SUNDRY NOTICES AND REPORTS ON WELLS

1. Type of Well: ☑ Oil Well ☐ Gas Well ☐ Other	5. Lease Serial No. LC 032511 (e)
	6. If Indian, Allottee or Tribe Name
	7. If Unit of CA/Agreement, Name and/or No. Langlie Jal Unit
	8. Well Name and No. Langlie Jal Unit #76
2. Name of Operator Penroc Oil Corporation	9. API Well No. 30-025-24881
3a. Address PO Box 2769, Hobbs, NM 88241 — 3b. Phone No. *(include area code)* (575) 492-1236	10. Field and Pool or Exploratory Area Langlie Mattix; 7 Rivers- Queen-Grayburg
4. Location of Well *(Footage, Sec., T.,R.,M., or Survey Description)* 1980' FNL & 660' FWL, Unit Letter E, Sec 9, T25S, R37E	11. Country or Parish, State Lea County, New Mexico

Well Name: Langlie Jal unit 76

API #: 30-025-24881

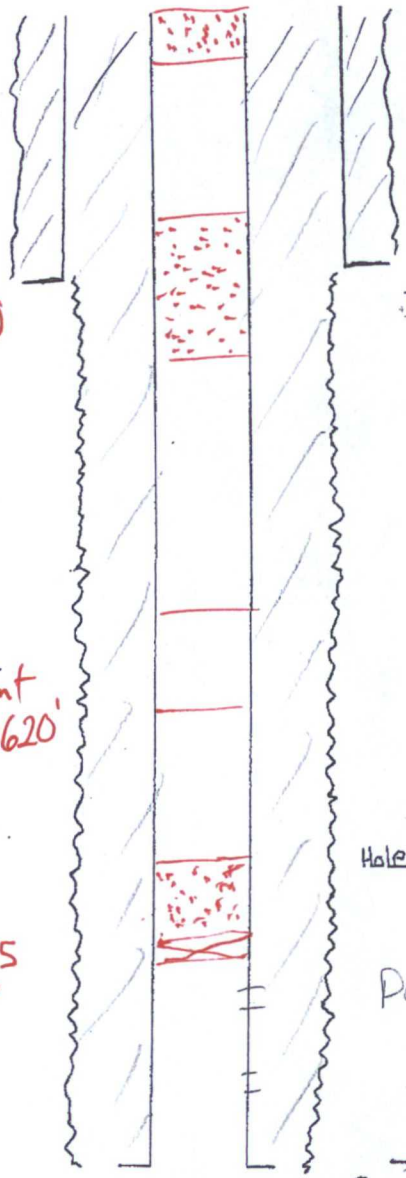
Drilled out

Test anchors. RU JWS. NU BOP. Set ½ steel pit. Previous operator set CIBP @ 3258' w/ ~~cement top @ 3242'.~~ PU work string. TIH, ~~tag PBTD. Circ hole w/ 10# gelled brine. Set 25 sxs plug @ 1800'. Set 25 sxs plug @ 800'. Set 15 sxs surface plug. Cut off~~ well head and anchors. Install DHM. Clean up location.

Plug 1 - Set CIBP @ 3255' + spot 25 sx Cmt on top. Pressure test or tag.
Plug 2 - Spot 25 sx class C cmt from 2750-2620'. WOC + Tag
Plug 3 - Spot 40 sx cmt from 1285-755'. WOC + Tag
Plug 4 - Spot 15 sx cmt from 200' to surf.

Spot 15sx cmt from 200' to surf

Spot 40 sx cmt from 1285' - 755'. WOC + Tag

Spot 25 sx cmt from 2750-2620' WOC + Tag

Set CIBP @ 3255 spot 25sx on top
